## Section 4.55(2) Modification Request

Development Consent DA10.2021.384.1

- Demolition of Existing Buildings
- Construction of a 3-Storey Mixed Use Retail/Residential Development including Basement

90-96 Jonson Street,  
Byron Bay

Figure 3: Sight Diagram Demonstrating 3 Storey Perspective

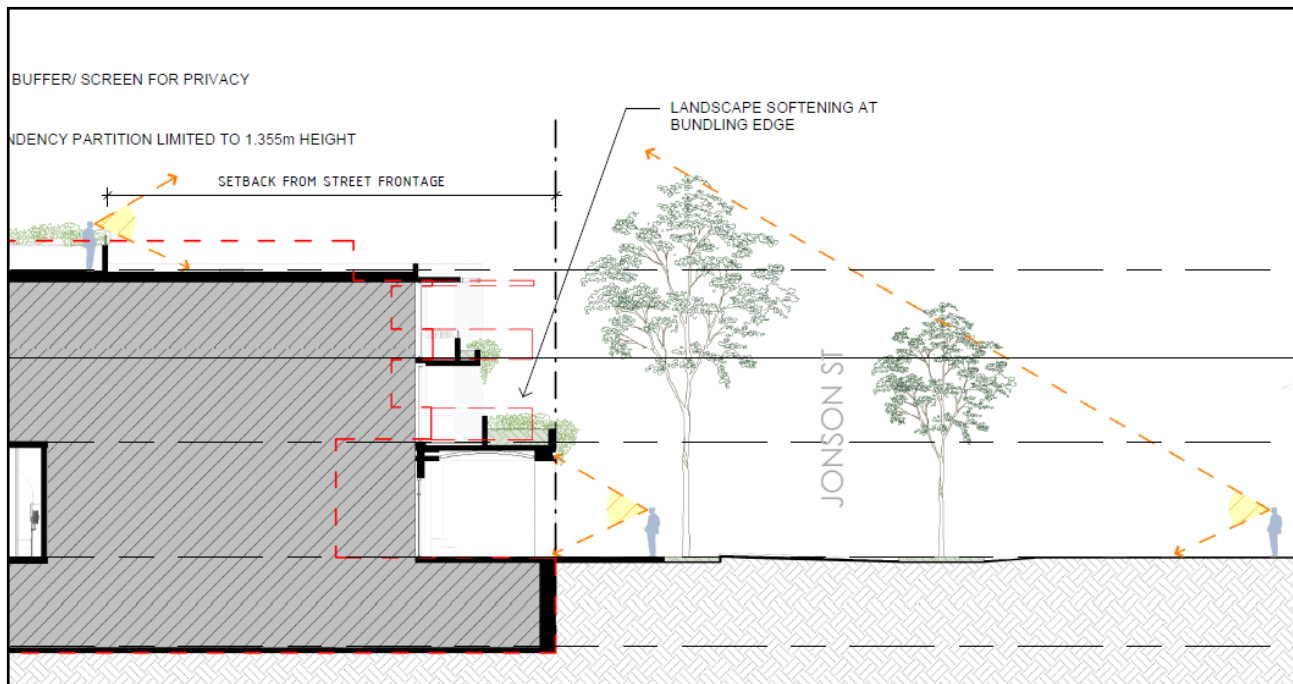
The roof top terrace is not considered a storey as the revised design has removed the ‘pop out roofs’ in lieu of greater landscaped planters. As the roof terrace does not contain a floor level or ceiling/roof above, it cannot be considered a storey. When also appreciating 3d visualisations from the public domain the roof top terrace clearly does not appear as a fourth storey. See **Figure 2** and **3** below.

Figure 4: Offset of Sewer Main & Basement Level

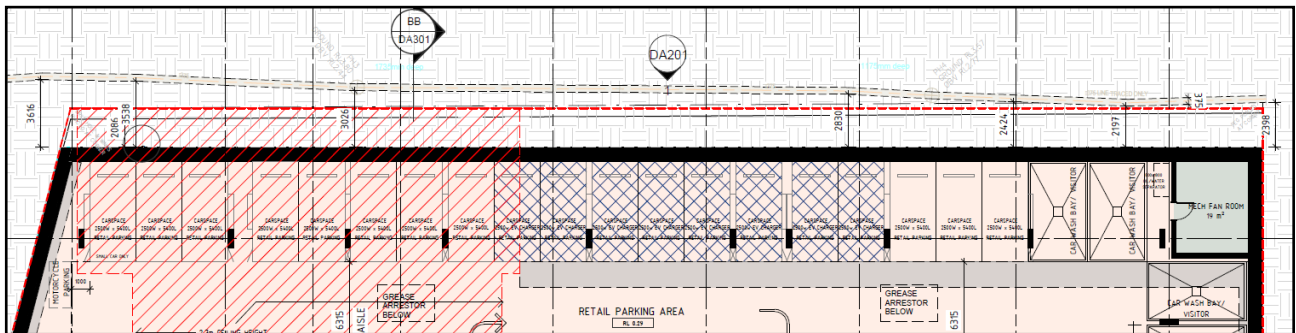
A sewer main is located adjacent to the northern boundary being a 375mm diameter sewer rising main. Potholing of this main has occurred noting the depth with the results provided in **Attachment 15**.

Consistent with Byron Shires Works in Proximity policy, an offset has been afforded of 1.5m minimum with an increased northern setback greater than what was originally approved under Development Consent No. 10.2021.384.1. As a result, the revised basement and ground floor complies with works in proximity policy and has been confirmed via Council Correspondence dated 30 January 2023 (refer **Attachment 19**).

Figure 7: Proposed Height Plan Analysis

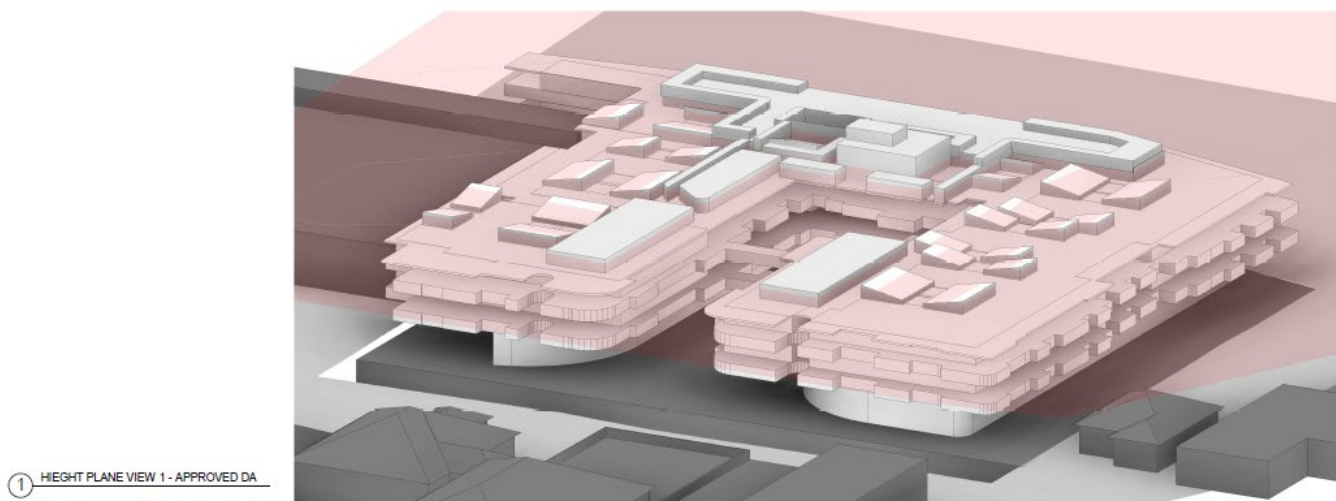
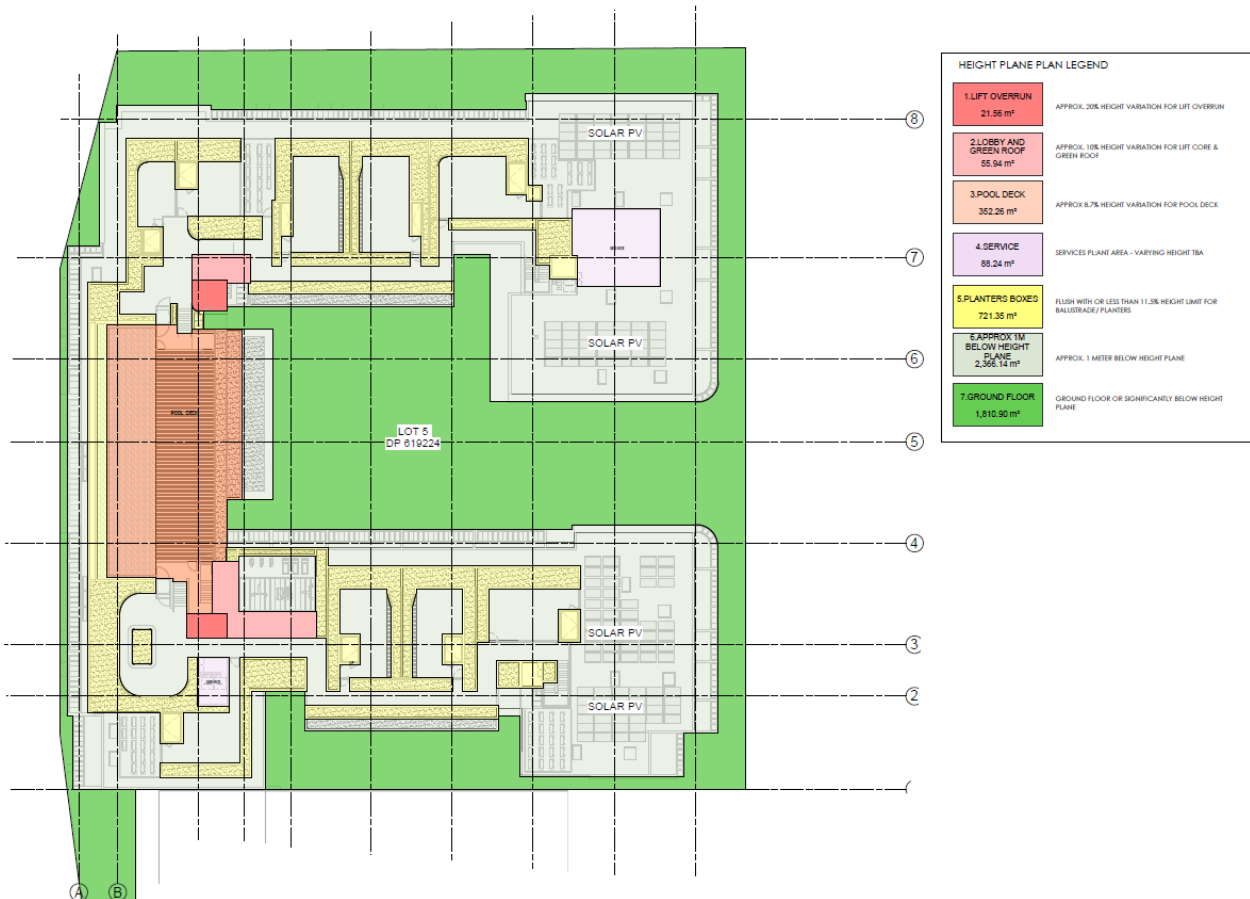
In regard to the Clause 4.3 of *BLEP 2014*, the revised development proposes a maximum building height of RL of 18.55 for the lift overrun on the roof top terrace with a maximum height of 14.75m above ground level (existing). This is generally consistent with the maximum height of the previously approved development DA10.2021.384.1 at 14.58m above ground existing and the minor increase in height would be imperceptible to the casual observer. Effectively, the main difference in the proposed plans with respect to building height is the provision of more usable space on the roof top terrace, however not all of the additional floor area is over the 11.5m building height, indeed most of this useable trafficable area (2,366.14m<sup>2</sup>) is 1m below the height plane. Whilst on face value (comparison of the approved DA10.2021.384.1 plans and that proposed in **Attachment 1**) there is an additional area of 316.82m<sup>2</sup> of additional usable space that is above the building height plane compared to the exiting approval, it appears that the previous approved plans have incorrectly noted 1,310m<sup>2</sup> of pop-out roofs as under the maximum height however when indeed these structures exceed the 11.5m height limit. In this regard, a total of 588.65m<sup>2</sup> in area that exceeds the height limit has been removed due to the removal of the pop-out roofs in lieu of the planter boxes.

So, subtracting the proposed additional area above the height limit (316.82m<sup>2</sup>) with the difference in area now below the height (588.65m<sup>2</sup>), there is in fact a net reduction in area exceeding the height limit beyond the previous approval of 271.83m<sup>2</sup>. This reduction is a preferred planning outcome and seeks to further reduce any amenity concerns and appearance as a fourth floor.
